Technical Memorandum

Re: WTP No. 5 Alternatives – Comparison of Opinions of Probable Cost

Date: November 30, 2018 **Project Number:** P05177-2018-002

III. Snow Kreilich Architectural Concept Development (Option 1E)

Figure 4 – Option 1D (SW View)

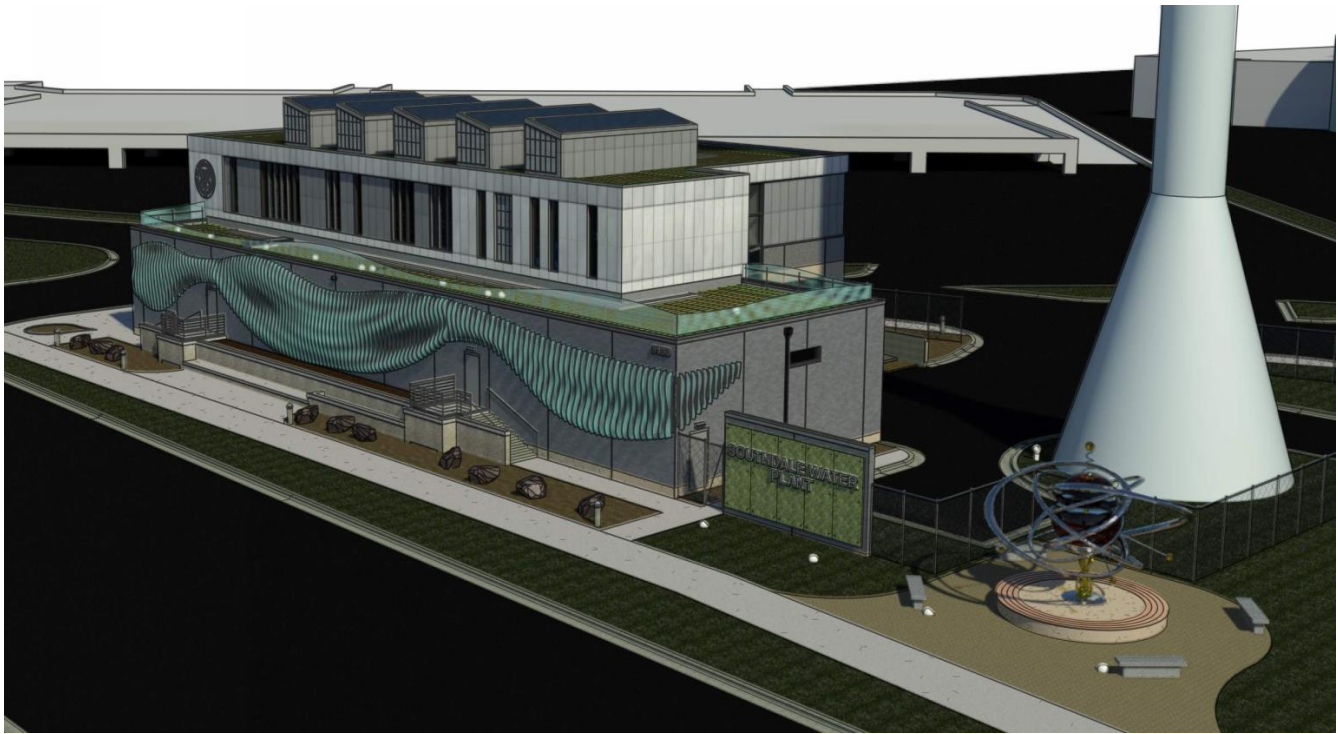
As previously noted, it was important to the City that the architectural aspects of this facility are impactful and establish the new WTP as an iconic piece of city infrastructure. The following upgrades were proposed to the original 95% design to accomplish the goal of creating a more impactful building.

1. Material finish changes = \$50,000
2. Full glass curtain wall on the north side of the WTP = \$176, 000
3. LED educational Wall = 100,000
4. Textured wall panel at north wall = \$32,000

5. Glass railing at parapet = \$50,000
6. Roof light stacks = \$175,000
7. France Avenue fins = \$392,000
8. Parklet site development = \$36,000 (does not include cost for public art)

9. Southdale side green screen and plantings = \$34,000
10. Sign Monument (30,000)
11. Green roof (complete upper green roof)= \$70,000
12. Upgraded plate settler to stainless steel = \$100,000

13. Increased quantity of cast in place concrete to accommodate potential staircase in NE corner of facility = 55,000
14. Increase quantity of structural steel to support modified roof framing = \$60,000

15. Increase in rebar costs for cast in place concrete due to steel tariff = \$87,000
16. Addition of precast beam to accommodate north face modification = \$50,000

17. Additional LED lighting and color changing controls = \$110,000
18. HVAC improvements to control the temperature on the north face = \$25,000

Figure 5 – Option 1E (NW View)

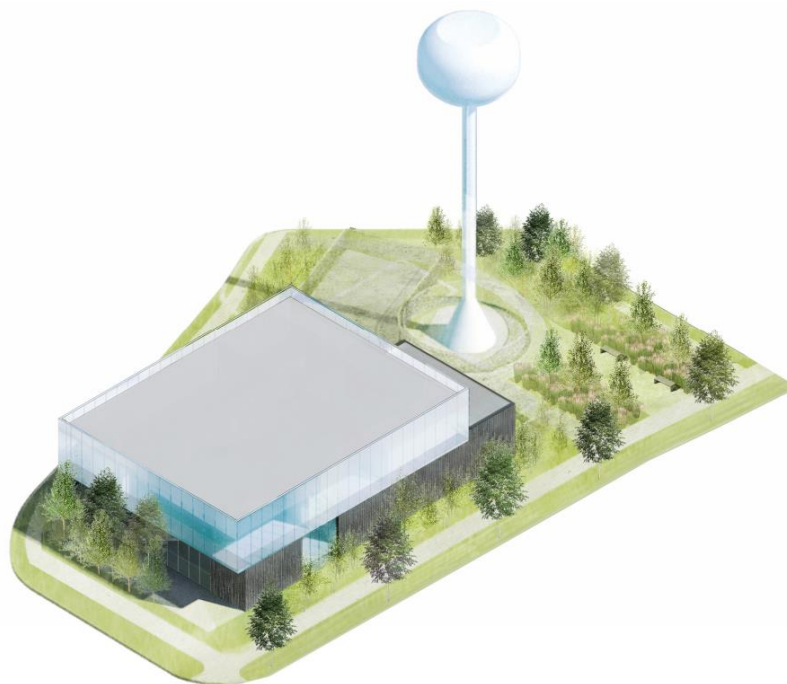
In addition to the construction cost estimate that was completed for this alternative, an operational evaluation was also completed to review the proposed floorplans and operational considerations that may impact the WTP design and future operation and maintenance by City staff. In general, the review comments reflect the professional opinions of the AE2S Project Team based on the available information. Detailed design may present additional challenges not identified in the preliminary concepts. Separation distances (only estimated based on the conceptual floorplans provided), revised Code review, and future Owner driven modifications may all further impact design. Images from the Snow Kreilich concept alternative are shown below to summarize the proposed changes. The left layout is the original design and the right layout are the proposed modifications for the First and Second floors. A cursory review of Option 1E is outlined in the following sections.

There are a significant number of exterior penetrations required to provide chemical venting, make-up air, HVAC features, etc. to the building to meet code requirements. The original design attempted to keep the equipment and vent penetrations off of the roof, by utilizing the vertical walls to accommodate the vent/louver systems. It appears that the lower level of the conceptual architectural rendering could still accommodate wall penetrations for chemical feed room venting, but the second level glass may necessitate that the other vents/louvers are directed through the roof. The appearance of the roof (especially from the adjacent Restoration Hardware and potential future high rise residences) has been a consistent topic of concern. Location of the visible mechanical appurtenances will need to be carefully managed.

Previous discussions with City staff and Officials had directed the team to avoid roof mounted equipment and/or penetrations whenever possible. The original design could likely locate any required mechanical equipment either within the building or hidden on the roof of the Garage, but there would need to be some provision for the vents/louvers.

Similar to the challenges noted with the mechanical equipment, the large amount of glass on the upper portion of the facility may create structural challenges for mounting and hanging piping and equipment inside of the building. A significant amount of mechanical piping, water piping, and electrical conduit will need to be installed within the facility to accommodate the needs of the required systems. Glass walls will not easily allow for equipment mounting and may increase construction costs.

In addition to the construction issues, there are also ongoing maintenance concerns. This facility will likely be very humid in the summer months. The humidity, together with the temperature differential, may cause fogging

and condensation on the glass. Similarly, in the winter months the significant temperature differential and internal humidity may cause ice buildup around the glass that needs to be removed regularly.

There are currently two (2) overflow pipes directed toward France Avenue. These overflow pipes are required by the Minnesota Department of Health and the elevation of the overflow pipes are critical, which was identified as a problematic design element. It should be considered how to best manage/hide the overflow pipes while still accommodating the architectural concepts. The discharge assemblies could likely be recessed into the structure, but we will still need to provide an outfall to the building exterior.

Building exits were a challenge for the team during meetings with the City Building Officials. The direction from the Building Officials to the design team was that the exits needed to lead directly to a “public way”, to provide the highest level of safety and security. During design meetings, the only area that was considered a “public way” was France Avenue. The future design will need to ensure that the exits lead directly to the “public way”, which may require additional doors on the west side of the building facing France Avenue.

The design/construction of a Water Treatment Plant on this property is subject to some level of review by representatives of Simon Properties. The primary item of concern indicated by Simon properties during design was the proximity of the northeast corner of the facility to the Southdale Ring Road. They have consistently reinforced the importance of maintaining the “maximum possible” separation distance to the Southdale Ring Road. The proposed revised concept encroaches on this corner and increases the depth of excavation near the road.

In general, there are no technical restrictions with moving the office, lab, and electrical room to the Second Floor but it is important to consider the following items:

1. Electrical Room - Conduits would need to be cast in concrete to reach the second level. This would thicken one of the walls, but not otherwise impact design.
2. Electrical Room - Provisions should be considered for future access to install large, heavy electrical gear when removal/replacement is necessary. This may include wider walkways to move equipment to/from elevator, bridge crane access, or removal panels to the exterior.
3. Office/Laboratory - Most water samples will be collected on the main floor requiring operational staff to travel up and down the stairs frequently.

The addition of an elevator would be necessary to meet Americans with Disabilities Act (ADA) Code requirements, since the Office and Laboratory spaces would be located on the Second Floor. If an elevator is added to the building it would be prudent to consider a freight elevator with the size and capacity to accommodate movement

of electrical and process equipment. It would also be potentially beneficial to make the elevator a 3-stop elevator that could access 1) Ground Level, 2) Main Operating Floor, and 3) Upper Level.

The Minnesota Department of Health will not allow the Detention Tank to be located above the Finished Water Clearwell (located on the below grade level). The conflict could likely be addressed by reconfiguring one or both basins, or potentially increasing the depth of excavation to maintain adequate Clearwell capacity. Another alternative may be to locate the Clearwell beneath the Filters, but this approach would significantly increase the depth of excavation immediately adjacent to the Southdale Ring Road potentially complicating construction and adding project cost. The capacity of the Detention Basin was increased slightly in the conceptual layout but that is not required. It is acceptable to increase the capacity to achieve architectural objectives, align walls, etc. But, increasing the capacity of the basin is not valuable to improving the treatment process.

The High Service and Backwash Pumps (and related piping systems) are located (partially) in the space proposed for the relocated Detention Basin. AE2S would propose orienting the (relocated) Detention Basin from north to south, in the northwest corner of the facility. We acknowledge that this would eliminate the transparency/window facing France Avenue. But, we could relocate the transparency/window feature to the north face. The transparency/window could be wider and potentially taller and open up a viewing corridor that extended from north to south through much of the facility. The viewing location would also be located in an area of "slower" vehicle traffic. This adjustment, although a significant architectural change, would address much of our concern about the pumps/piping and the Clearwell item noted above.

Normally, we would discourage use of "glass" on the ground level of a Water Treatment Facility. It can compromise security and result in potentially expensive vandalism. However, we also understand the direction of the project in trying to achieve a level of transparency, so we would request consideration of reasonable measures to address safety/security.

Review of the proposed turning radius appears to be adequate, but consideration should be given for a City truck parking while a chemical delivery truck is using most of the drive space to turn and access the garage.

Consider the location of the Electrical equipment (specifically the transformer), currently proposed to be located immediately south of the Garage. The generator should have a minimum of 10-feet of clearance on all sides for airflow, as well as access for refueling. Typically the fuel access is on the side of the generator, but it would likely work to access the end of the generator, if it remained oriented as shown. The transformer needs to be located such that is accessible by the electrical utility (Xcel) and has at least 10-feet of clear space in front of the double doors. AE2S would recommend potentially locating the transformer to the south of the proposed generator and screening it with bushes. The transformer does not need to be located on a paved surface.

The loading dock feature at the main entrance (when combined with the double doors) provided a valuable feature for future removal and replacement of equipment, for future maintenance. Losing the loading dock feature and transporting materials and equipment up/down stairs is less desirable.

The perimeter fence around the building/property is not required, but typical for buildings of this nature. The decision for installation of any perimeter fence is at the discretion of the Owner depending on their concern for site safety/security. A fence may potentially reduce liability issues on City property.
